0.1 Manual amendments

No.	Page	Description	Date
1	0.5, 0.6, 4.14-4.16 diagrams 7, 11, 12	Manual revision TN413/2	September 2003
2	0.6, diagrams 1 and 11	Manual revision TN413/3	May 2004
3	0.4, 0.6, 1.9, diagram 7	Landing gear / over centre lock in extended position TN413/7	Nov. 2004
4	0.4, 0.5, 0.11, 2.6, 6.2, 6.4, 7.1	Manual revision TN413/8	January 2005
5	0.4 - 0.6, 0.10, 1.9, 1.10, 4.7-4.9, diagrams 17, 18	landing gear positive locking device TN1000/13	February 2008
6	0.4, 0.6, 0.10, 1.14 diagram 6a	ÄM 1000-02 Fin ballast tank valve and handle	March 2008
7	0.4, 0.5, 0.6, 1.2, 2.6, 4.2, 6.2, diagrams 3, 9, 11, remove page 2.7	Manual revision TN1000/16	May 2008
8	0.4, 0.5, 0.6, 0.10, 4.8, 4.9, diagram 7a	ÄM1000-04 production version of the positive locking device	Oct. 2008
9	0.4, 0.6, 0.10, diagrams 20-22, drawings 10E3, 10E4, enclosure 1	Electrically operated main landing gear TN1000/14	November 2008
10	0.6 and 0.10, diagram 21, Encl. 1 pages 2, 2a and 8. drawing 10E4 issue E	Electrically operated landing gear, device to provide higher current for resetting the emergency extension gas strut TN1000/19	October 2010

d) Switch emergency extension system (optional with TN1000/19, st

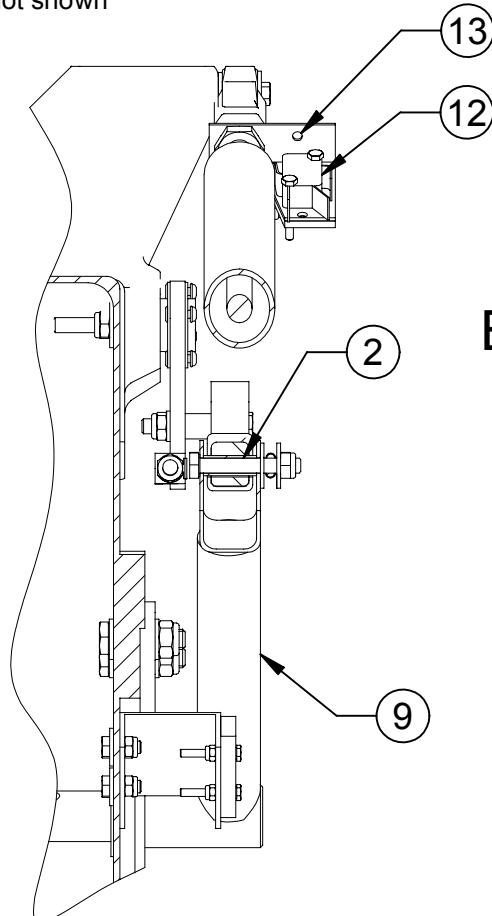
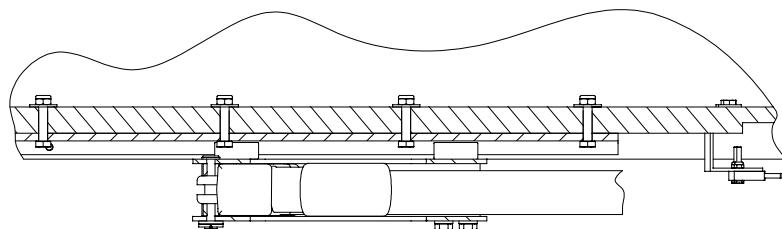
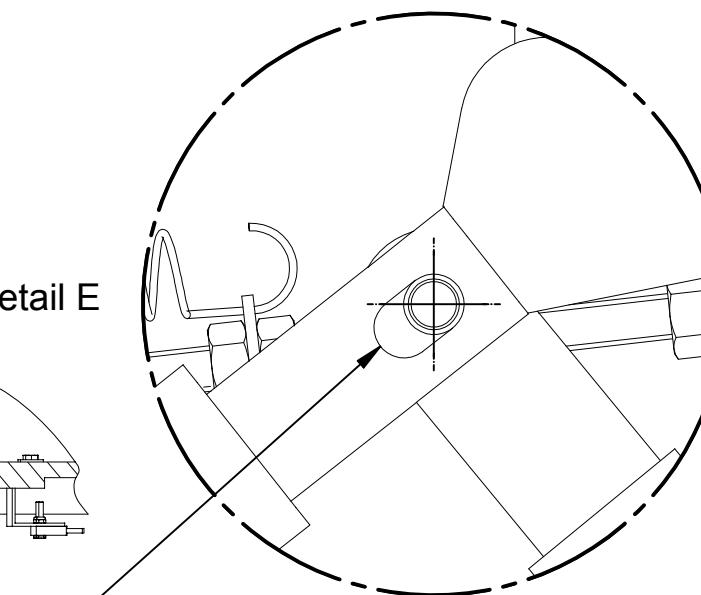
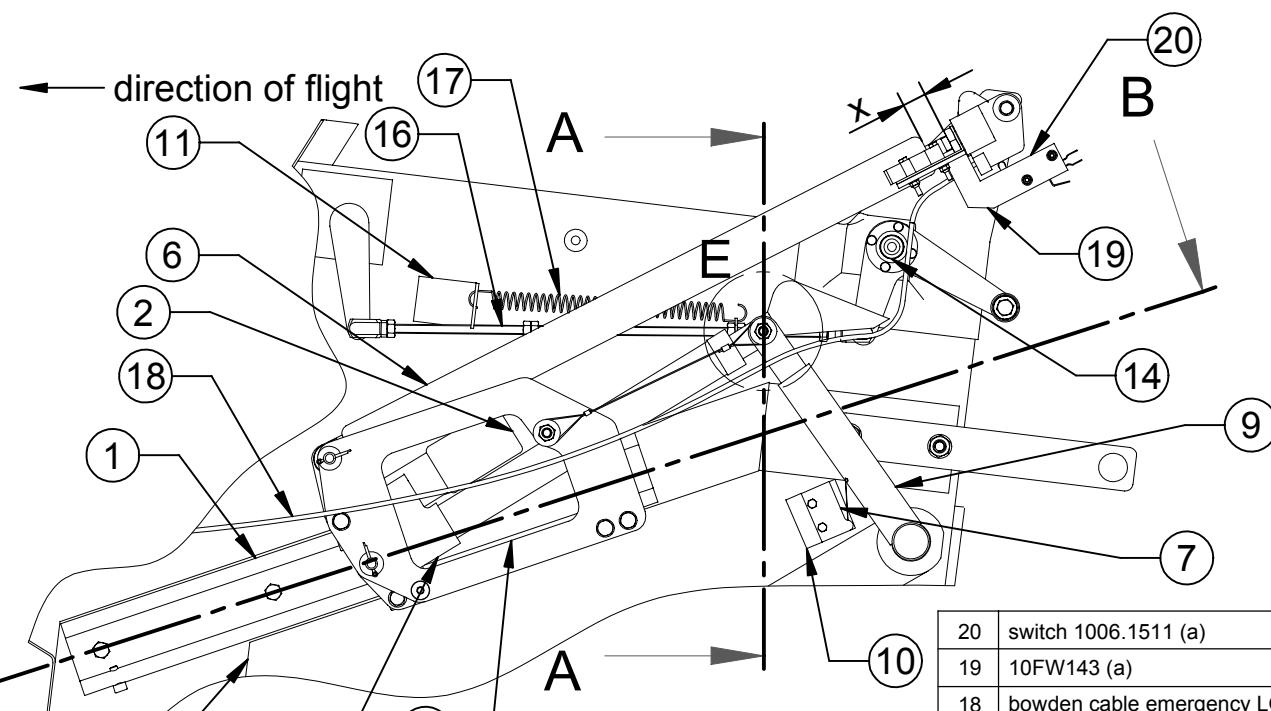
This switch (position 20 in diagram 21) activates higher current for the spindle drive via the LG control unit to reset the gas-strut as long as one of the emergency extension handles is pulled. The switch is mounted to a bracket 10FW143 which is mounted to the bracket 10FW120 see item c). The switch is activated by the deblocking lever in the upper gas-strut end. In case the spindle drive has not enough power to reset the gas-strut check the function of the switch. To accomplish this disconnect the 2 wires from the switch. With one of the emergency extension handles pulled the resistance between these 2 terminals must be zero. If necessary adjust the switch by bending it's arm.

(a) only with TN1000/19 applied,
standard from ser. no. 10-157 on
